# Access Compliance Report

## Public Rights-of-Way

### (Curb Ramps)

Intersection ID: 8329	Main Street: BEATTIES_FORD_RD	Cross Street: LASALLE_ST	Location: SW
ADA ID: BAEED3D853B3	Ramp Type: Perp	Initial Pass/Fail: Fail	Overall Compliance: No
Severity Score: 8.75			
Codes/Mitigation Info/Possible Solution		Field Measurements/Component Compliance

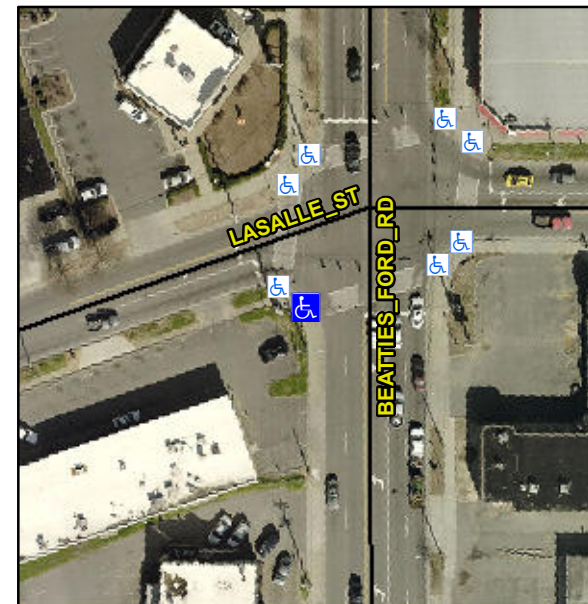
**Not Found, R304.5.1**

Compliance	Description	Data	Compliance	Description	Data
N/A	Ramp Length (in)	84.0	Yes	Ramp Slope (%)	7.1
No	Ramp Width (in)	44.0	Yes	Ramp XSlope (%)	1.6
N/A	Flare Type LT	N/A	N/A	Flare Type RT	N/A
N/A	Flare Slope LT (%)	N/A	N/A	Flare Slope RT (%)	N/A
N/A	Flare Traversable LT?	N/A	N/A	Flare Traversable RT?	N/A
N/A	Landing Length (in)	N/A	N/A	DWS Provided?	N/A
N/A	Landing Width (in)	N/A	N/A	DWS Contrast?	N/A
N/A	Landing Slope (%)	N/A	N/A	DWS Length (in)	N/A
N/A	Landing X Slope (%)	N/A	N/A	DWS Full Width?	N/A
N/A	Landing Curb? (Y/N)	N/A	N/A	DWS Offset (in)	N/A
N/A	Shared Landing?	N/A			
N/A	Gutter Ponding?	N/A	N/A	Gutter Slope (%)	N/A
N/A	Gutter Lip Ht (in)	N/A	N/A	Gutter X Slope (%)	N/A
N/A	Painted X Walk1?	Yes	N/A	Painted X Walk2?	N/A
	X Walk 1 Direction	To NE		X Walk 2 Direction	N/A
N/A	X Walk 1 Width (in)	120.0	N/A	X Walk 2 Width (in)	N/A
	X Walk 1 Slope (%)	3.0		X Walk 2 Slope (%)	N/A
	X Walk 1 X Slope (%)	0.3		X Walk 2 X Slope (%)	N/A

**Remove & Replace Entire Ramp.**
